TOWN OF JACKSON PLANNING & BUILDING DEPARTMENT

Date: December 9, 2022	REQUESTS:
Item #: P22-288	
Planner: Katelyn Page	
Phone: 733-0440 ext. 1302	
Email: kpage@jacksonwy.gov	
Owner Carol & Ramon Tome 3775 Randall Mill Rd.NW Atlanta, GA 30327	
Applicant Cornelius Kinsey – Kinsey, LLC PO Box 12258 Jackson, WY 83002	
Please respond by: December 23, 2022 (with Comments)

The applicant is submitting a request for a Grading Pre-Application Conference for 410 E Gill, legally known LOTS 1,2,3, BLK. 5, L.G. GILL SUBDIVISION PIDN: 22-41-16-27-3-08-002

Name/Description: Tome Single-family residence with ARU

REVISIONS

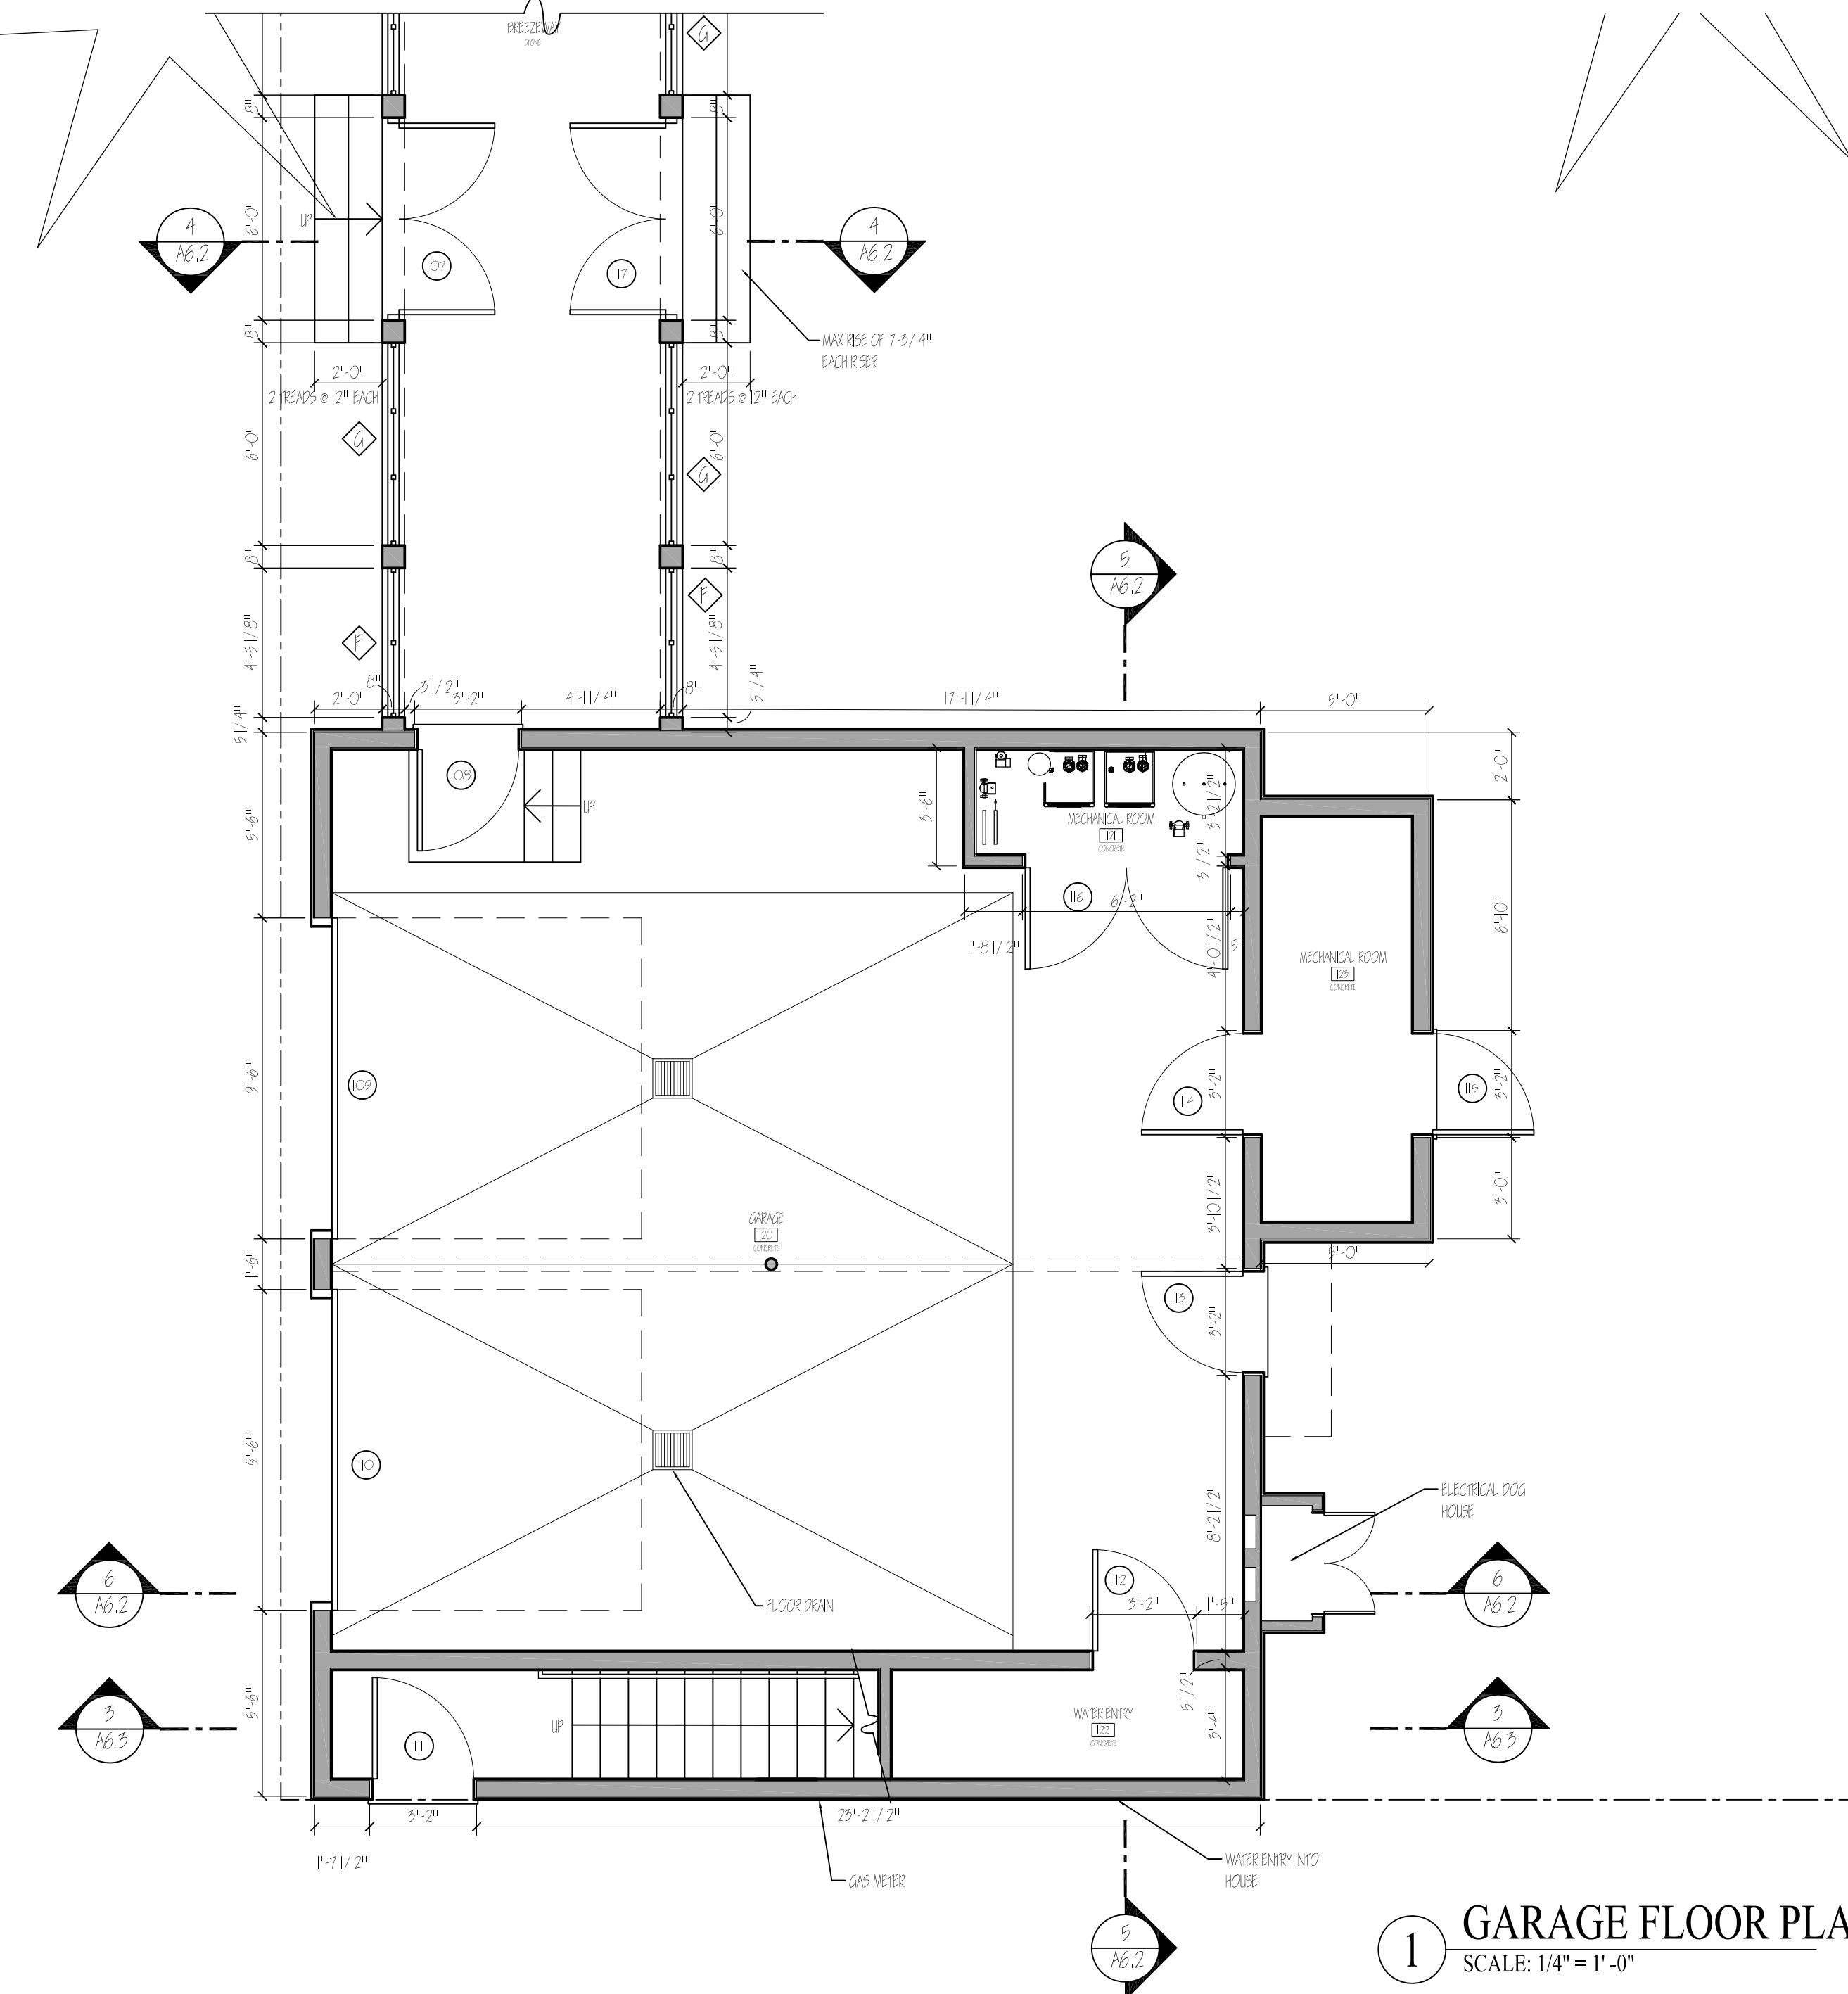
- Structure does not meet primary street setback of 20'
- Revise encroachment - Porch encroachment on E. Gill is must be no greater than 6'. (Sec. 9.4.8.J.a) Cornices, canopies, eaves, decks (covered and uncovered), porches, balconies, bay windows, chimneys and similar architectural features may encroach into a front yard by not more than 6 feet.

- Need ARU parking
- Orientation
- “Detached” non detached with walkway
- Front encroachment is greater than 6' (6'-7") (A2.2)
- Clarify building height
- Verify parking setbacks
